Amendment Application (ED Act) Town Planning Assessment

The Amendment Application relates to the existing PDA Development Approval (DEV2020/1124/3) over the site at 12-18 Thompson Street, Bowen Hills for a PDA Development Permit for Material Change of Use for Office, Research and Technology Industry, Health Care Service, Hospital, Food and Drink Outlet (<250m²), Shop (where located at ground level and not exceeding 250m² per tenancy), and Park and a Preliminary Approval for a Material Change of Use for a Master Plan for Office, Research and Technology Industry, Health Care Services, Hospital, Food and Drink Outlet (<250m²), Shop (where located at ground level and not exceeding 250m² per tenancy), Showroom, Warehouse, Indoor Sport and Recreation (Gymnasium), and Park. A copy of the current approval is contained in **Appendix A**.

Figure 1: Proposed building height

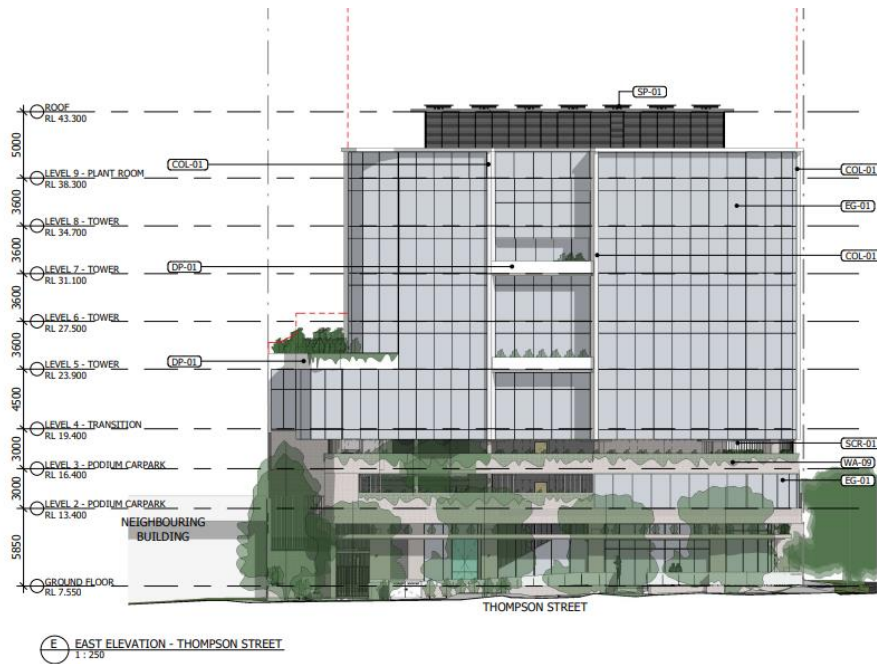
As a consequence of changes in the demand for commercial / healthcare floor space together with construction and project viability and delivery aspects, the Applicant proposes to reduce the building height of Tower 1 from 14 storeys to eight (8) storeys. The revised building height outcome satisfies the building height outcome for the Mixed Industry and Business Zone under Development Scheme and will allow the Applicant to proceed with the construction and delivery of the development immediately.

The eight (8) storey building height will be achieved by:

- Removing one (1) podium car parking level; and
- Removing five (5) levels of tenancy space, including the roof terrace level.

Figure 1 illustrates the changed building height outcome.

Figure 3: Comparison of approved basement and mezzanine levels

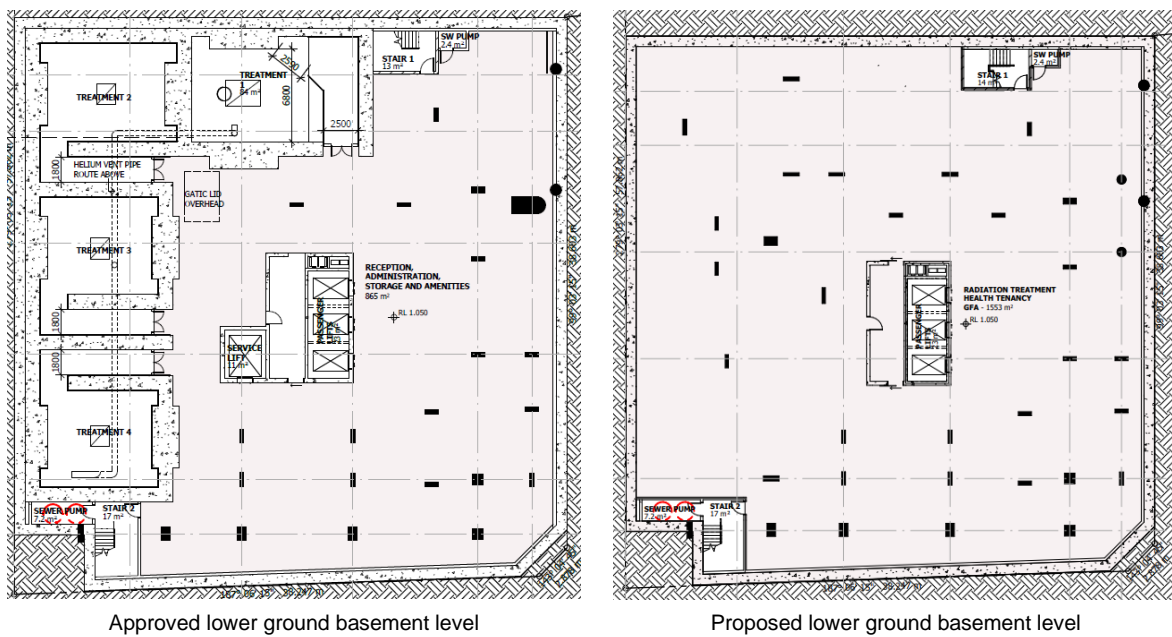
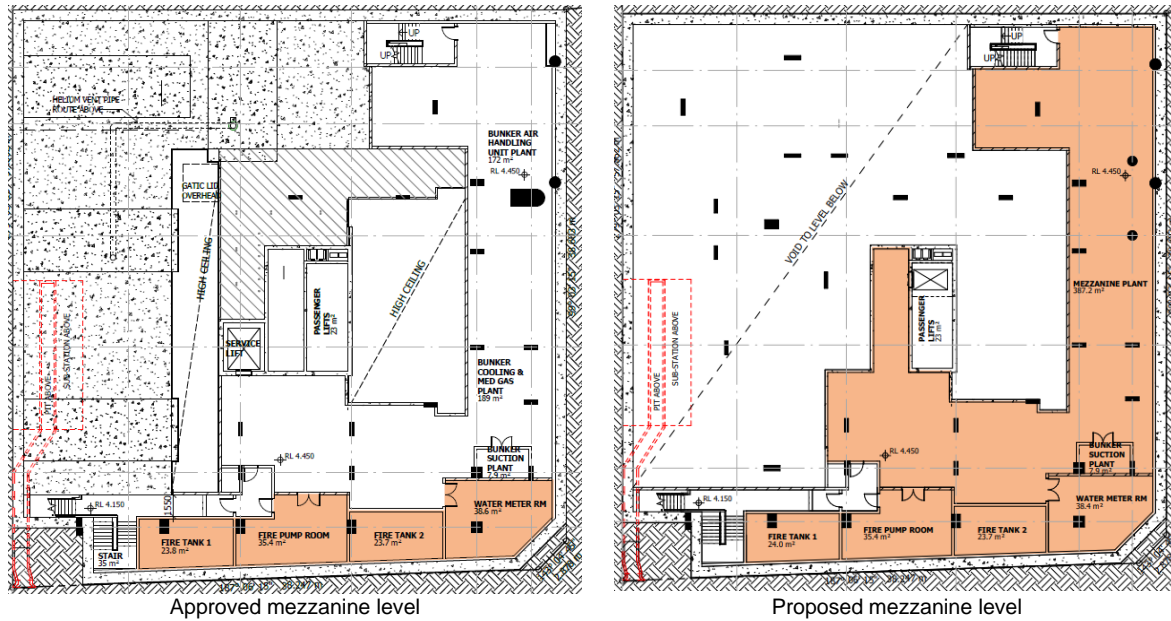
The hospital operator will maintain the cancer treatment bunker in the basement level, however instead of providing four (4) treatment rooms plus the reception / administrative space, the proposal will provide a single space that is able to be used for radiation purposes. Other minor changes include the removal of the service lift. For further detail refer to **Figure 3**.

The Mezzanine level remains generally consistent with the Amendment Approval, except for the removal of the dedicated service lift and minor changes to the configuration of some of the plant / service spaces.

Figure 4: comparison of approved and proposed ground level

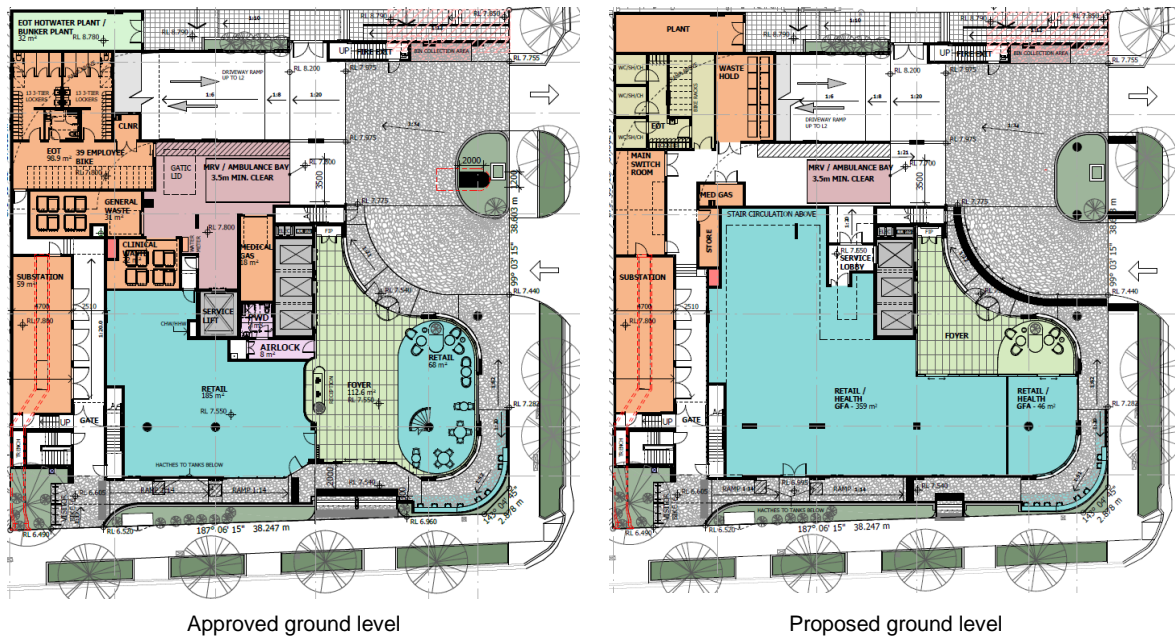
The following minor changes are proposed to the ground level configuration. A comparison of the approved and proposed ground level layout is included in **Figure 4**.

- Increase in the provision of retail floor space from 253m² to 392m² of gross floor area, providing additional ground level activation. The change to the retail space includes the removal of the internal stairs that connected to the mezzanine space, which continues to be provided and will contribute to the activation of the podium.

- Reconfiguration of the foyer to gain access from Murray Street only as a consequence of the increased retail floor spaces which has been accommodated to Thompson Street.

- Minor changes to the pedestrian pathway resulting in a straighter alignment along Thompson Street. Pedestrian access (including two separate access points along Thompson Street) to and from the development remains in locations consistent with the Amendment Approval.

- Change to configuration and a reduction in the size of the EOTF. The area of the EOTF is proposed to reduce from 98.9m² to 59.3m². The proposed EOTF will accommodate 26 bicycle spaces, which is a reduction from the 45 spaces under the Amendment Approval.

Figure 5: Rooftop Plant

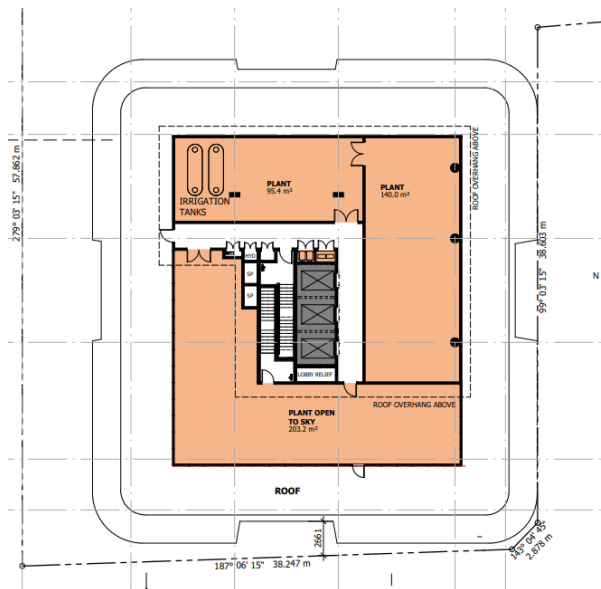
The development proposes a dedicated plant room on the roof of development (Level 9 under the updated Architectural Plans). The proposed plant room accommodates the plant rooms that were accommodated within the tower levels under the Amendment Approval but have been removed as part of this Amendment Application. The roof plant is centralised on the roof (to minimise its visibility from the surrounding context), is integrated into the overall architectural design of the building and includes solar panels on top of the plant, consistent with the solar panels that were accommodated under the Amendment Approval.

Figure 5 illustrates to proposed rooftop plant.

Figure 6: Comparison of approved and proposed south façade

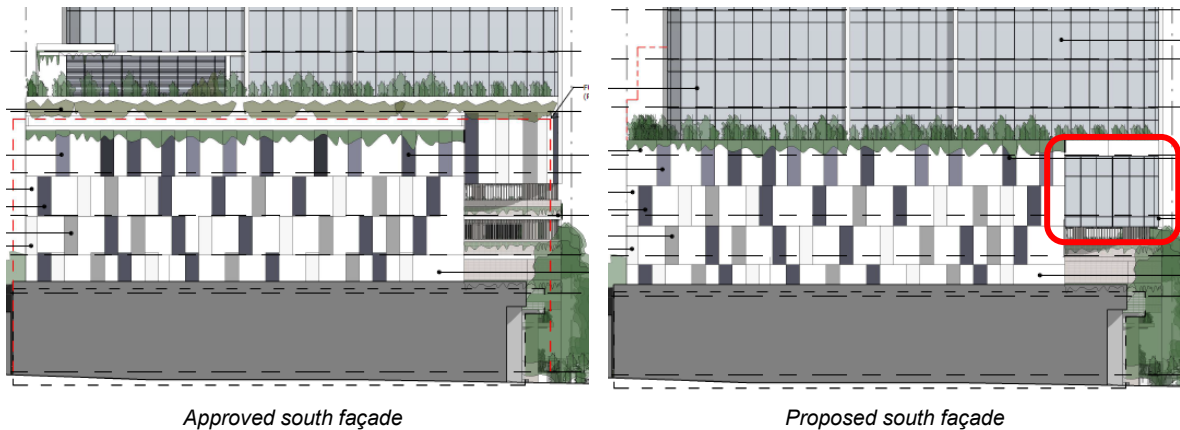
- Within level 4 of the podium adjacent to the southern boundary the development has introduced a glazed element, previously identified as rendered and painted block work. The glazed element will provide variation in the treatment of the podium as well as an active element to the southeast corner of the podium. Refer to Figure 6.

Figure 7: Comparison of approved and proposed west façade

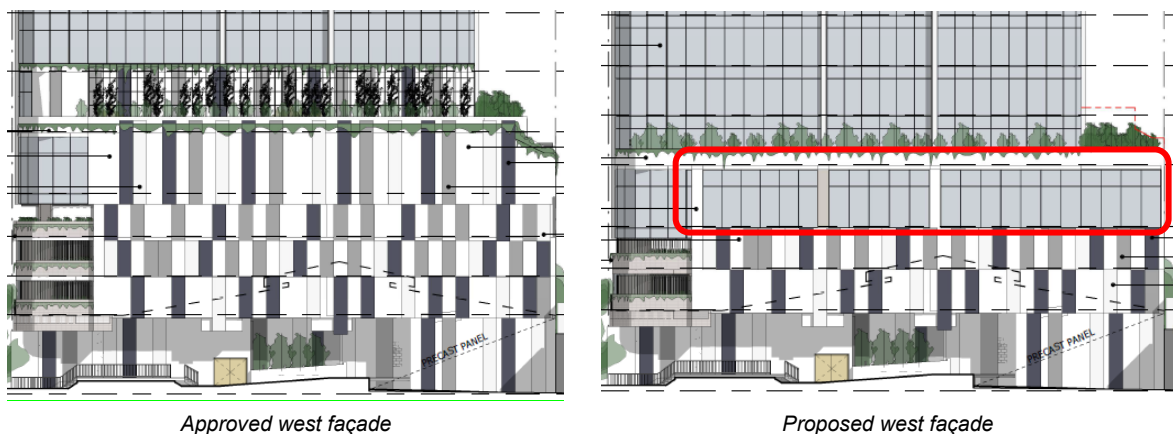
- Glazing is proposed at level 4 to the western elevation, previously identified as rendered and painted block work. The glazed element will provide variation in the treatment of the podium as well as an active element to the western elevation. Refer to **Figure 7**.
